SCI-823-0.00
PID Nos. 19415, 77366, 79977

Value Engineering Study Report
Draft Stage 2 Design Phase

re: SCI-823-0.00, PID Nos. 19415, 77366 and 79977, Portsmouth Bypass
Harrison, Jefferson, Madison and Porter Townships, Scioto County
Value Engineering Study Report

DESIGNER AGENCY: TransSystems
 DATE: 12/7/06
 REVIEWED: JRC
 DRAWN: AWB
 DESIGNED: PJP
 CHECKED: MSJ
 SCOTO COUNTY STA. 483+91.43 STA. 486+23.57
 SITE PLAN: SCI-823-6.81
 BRIDGE NO. SCI-823-0917-L
 S.R. 823 OVER PORTSMOUTH-MINFORD RD. (S.R. 139)
 PID 19415
 1/7
 561/571

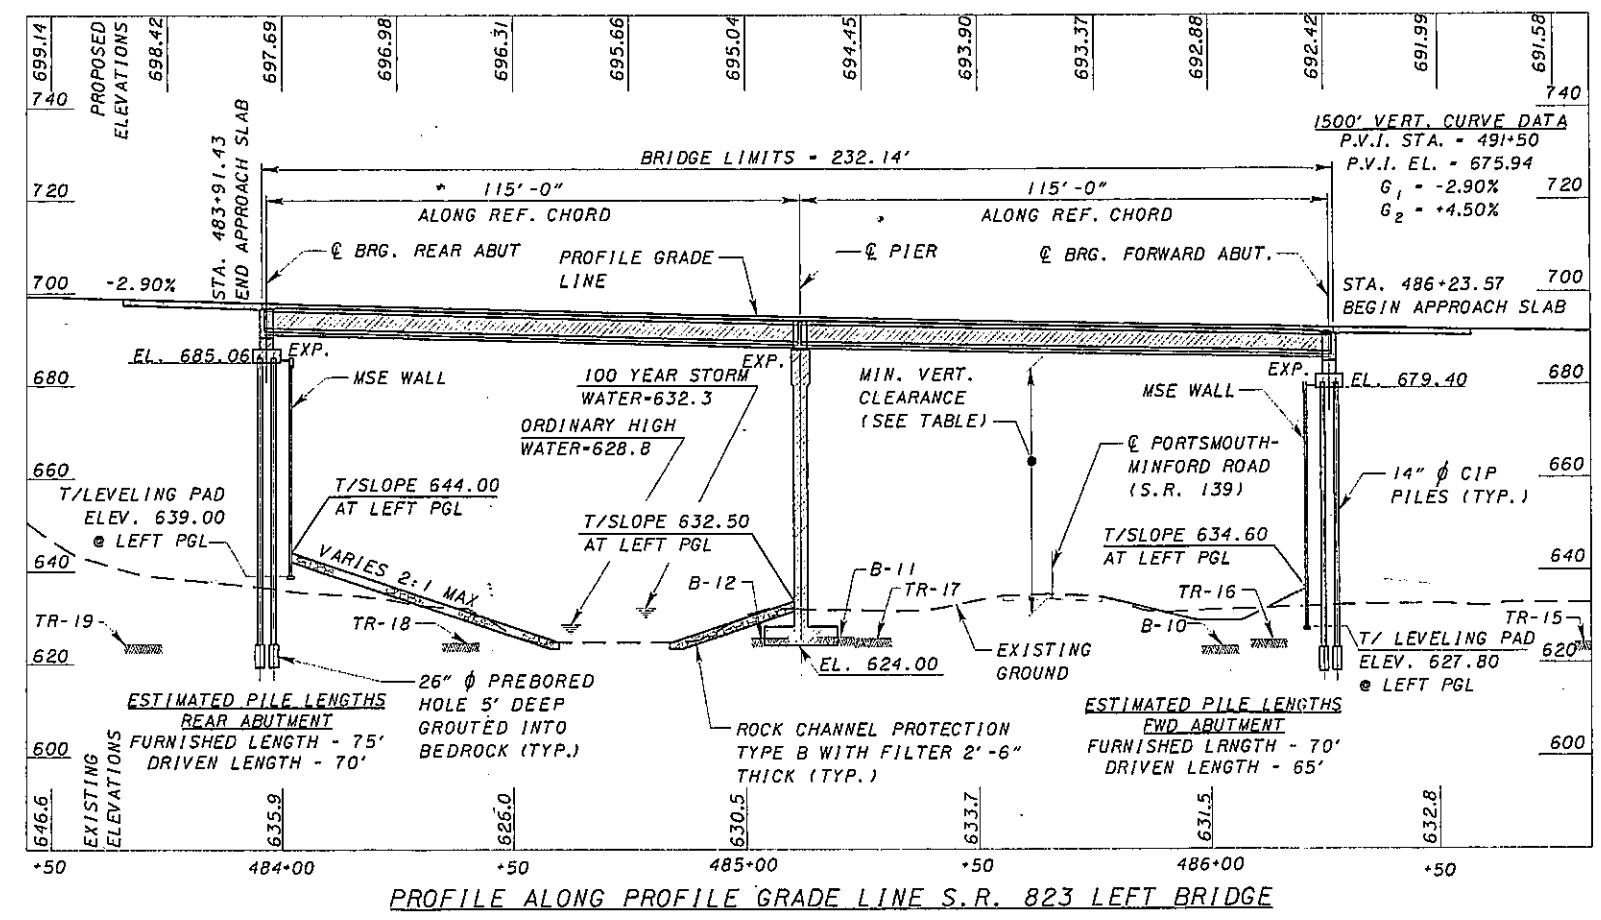
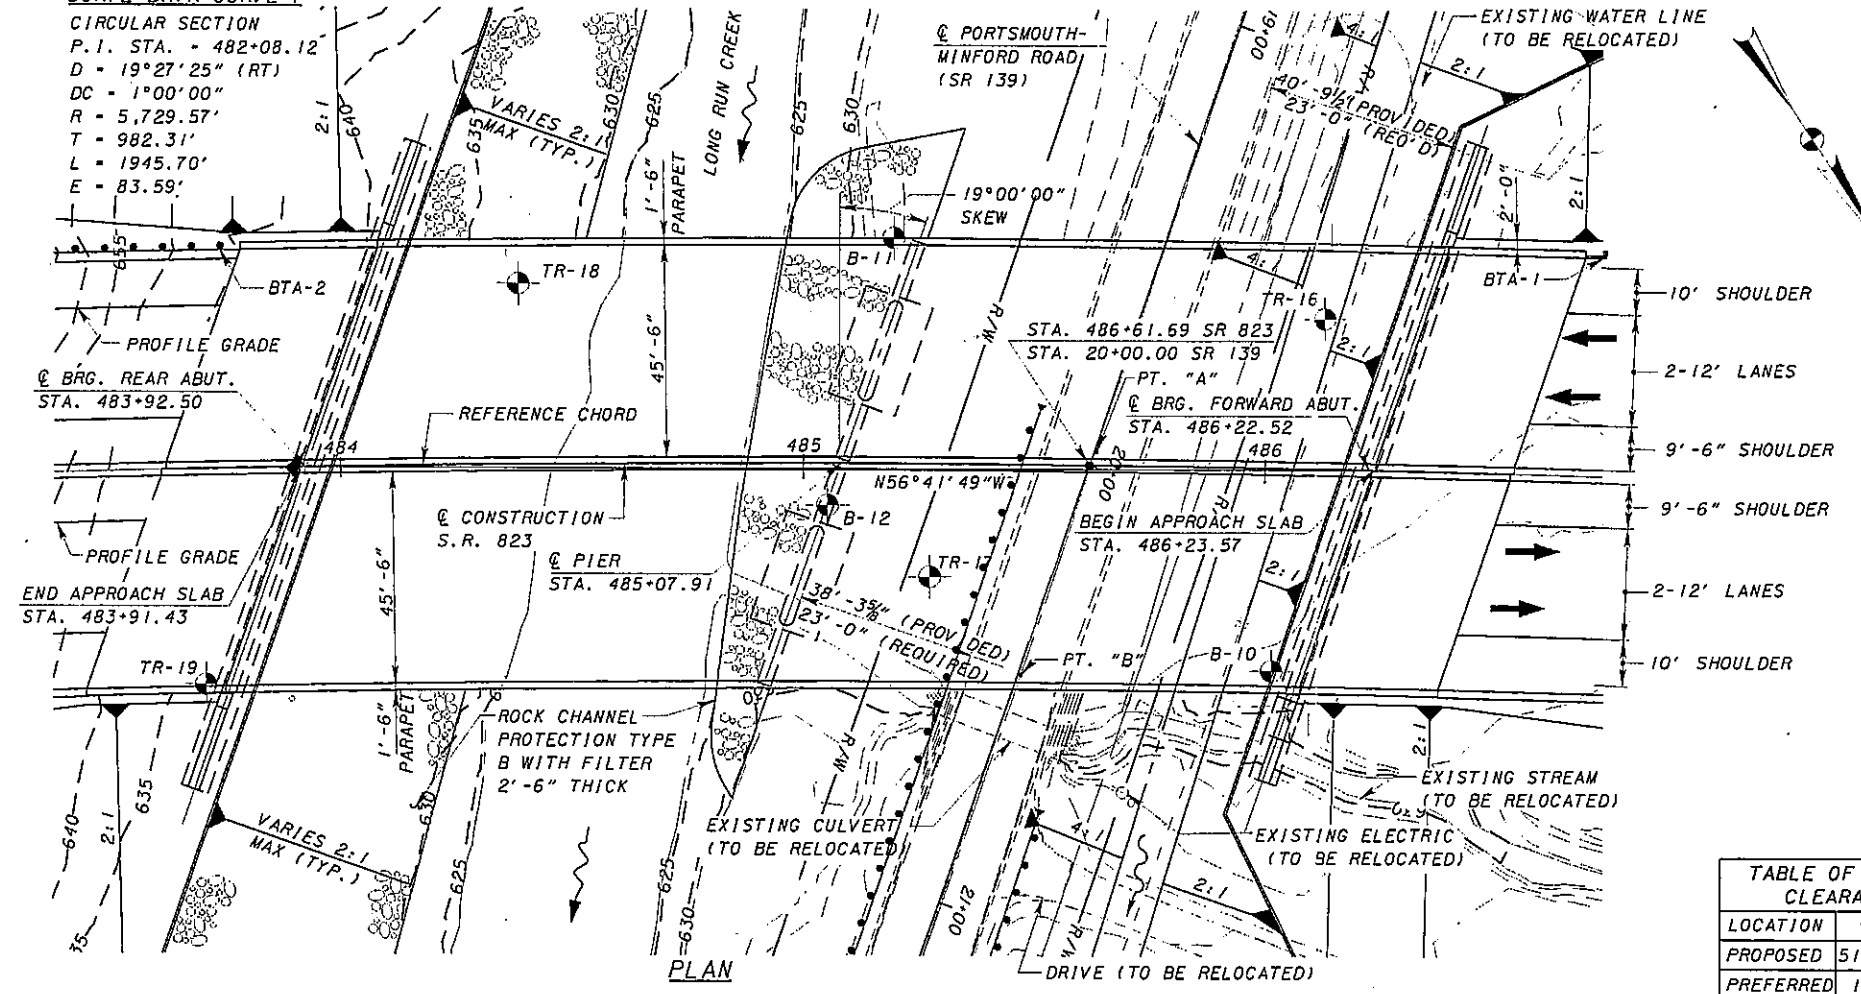
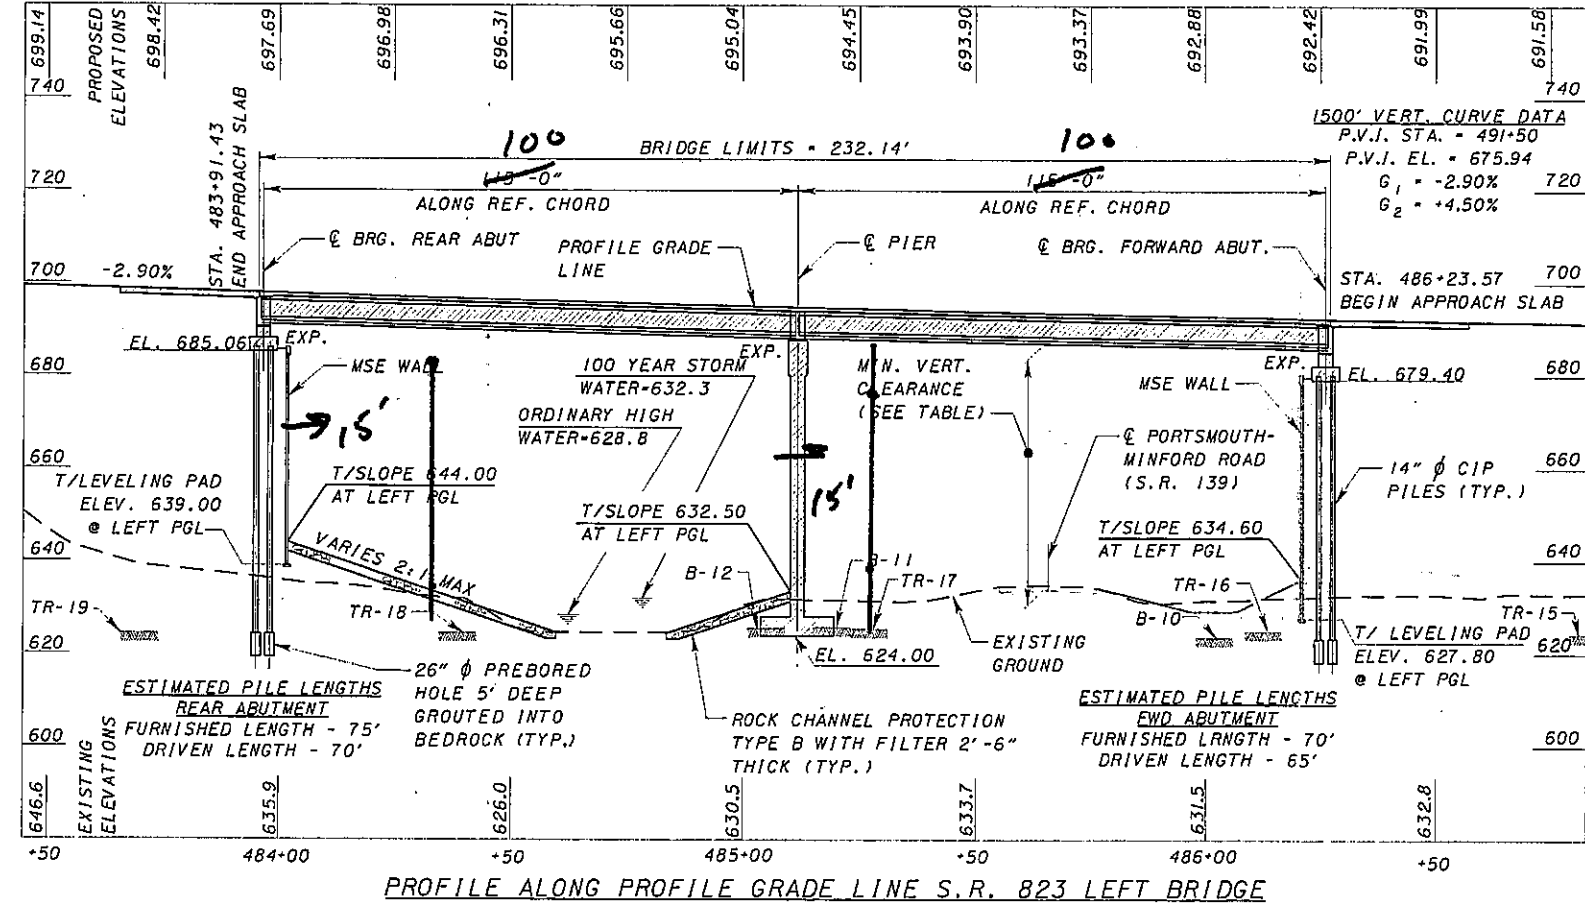
- SCI-823-0917 L & R - Potential to shorten spans by 15 ft. each;
- SCI-823-1018 L & R - No change, it was determined that MSE walls are beyond normal practice;
